Council assessment of Clause 4.6 request to vary height of buildings development standard

Visual representation of height of buildings

Figure 1: Aerial view demonstrating the components of the development above (shown in grey) and below (shown in red) the 14 m height plane.

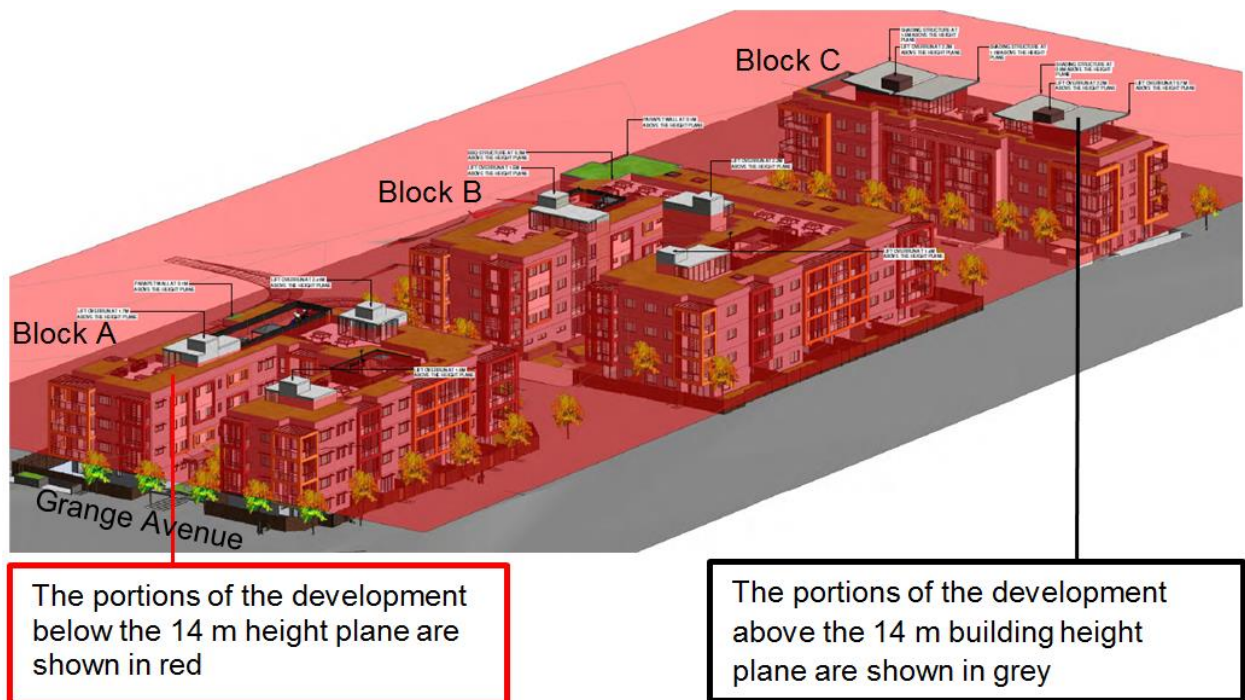
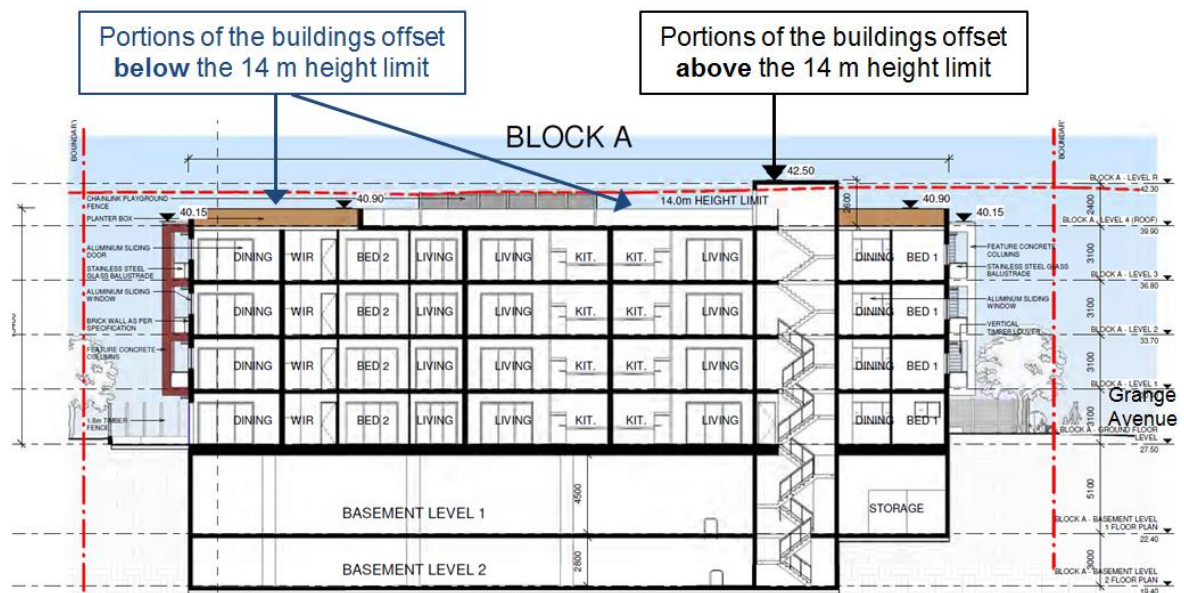
The underlying objective of the height of buildings development standard is still considered relevant to the proposal. Compliance with the development standard is, in this circumstance, considered both reasonable and necessary. The reasons for this relate to the poor development outcome of Block C, including:

- The parts of the proposed building envelope which exceed the height limit result in additional overshadowing impacts on the adjoining properties to the south. The cumulative impact of the overshadowing from the compliant component of the development, as well as the part of the rooftop structures which exceed the height limit, severely detract from the ability for direct solar access to be received by the nearby properties, which are also capable of future residential flat building developments.

- The lift overruns are not suitably placed as they are visible from the street and will overshadow adjoining properties.
- Excessive rooftop structures to service the communal open space area in the form of 2 sets of lobbys, lift overruns, fire stairs, store rooms and bathrooms. There are no other communal open space areas provided on the site that are accessible to residents. The applicant has nominated some ground level setback areas as communal open space. However, these landscaped areas are inaccessible and not usable.

Figure 2: Extracts from the Section Plans taken through Blocks A, B and C demonstrating the components of the development above and offset below the 14 m height plane.

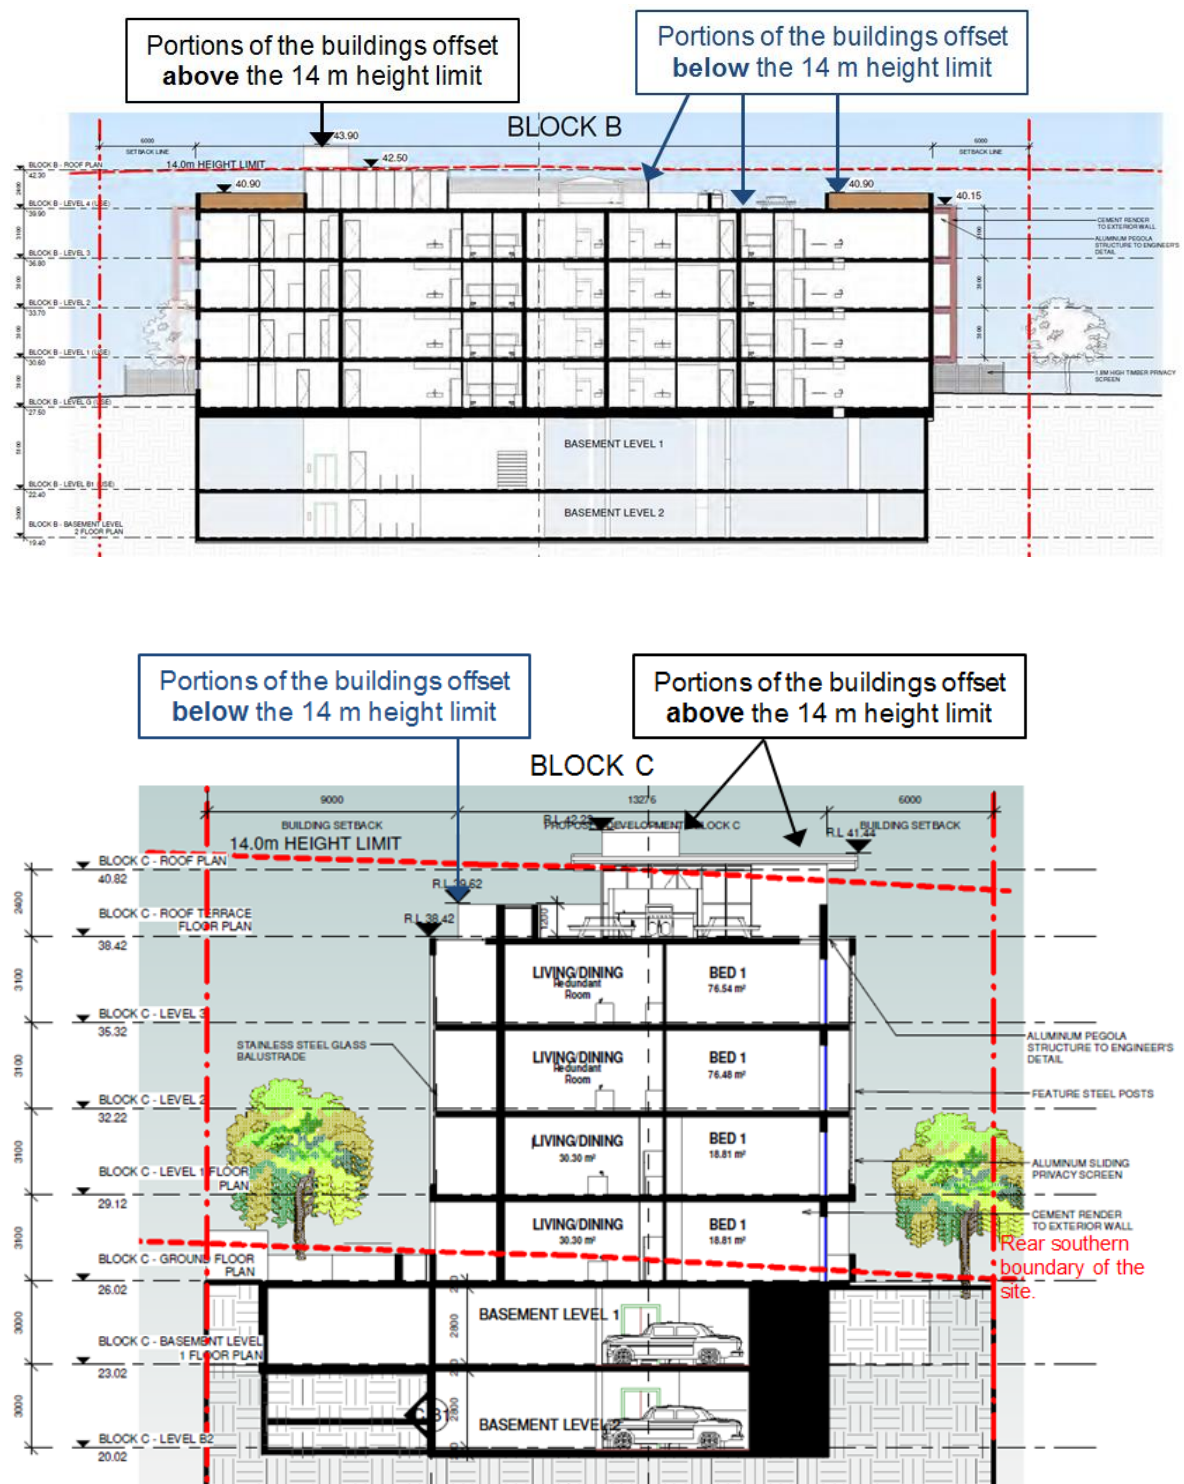
- The building is not appropriately stepped to reflect the slope of the site and to coordinate with the levels of the future roads and adjoining sites. This includes ensuring that the levels of the ground floor apartments are afforded with an appropriate amount of amenity given their relationship with the new road levels. In particular, the ground level apartments at the western end of the building are up to 2 m below the level of the new local road between Blocks B and C.

- The proposed design for Block C does not provide stepped building forms that accommodate the changes in the landform; including failing to provide basement access for waste vehicles, and basement levels and loading facilities which service the needs of residents.
- The proposal fails to promote good design and amenity, and fails to create a diverse and attractive neighbourhood based on strong urban design principles.
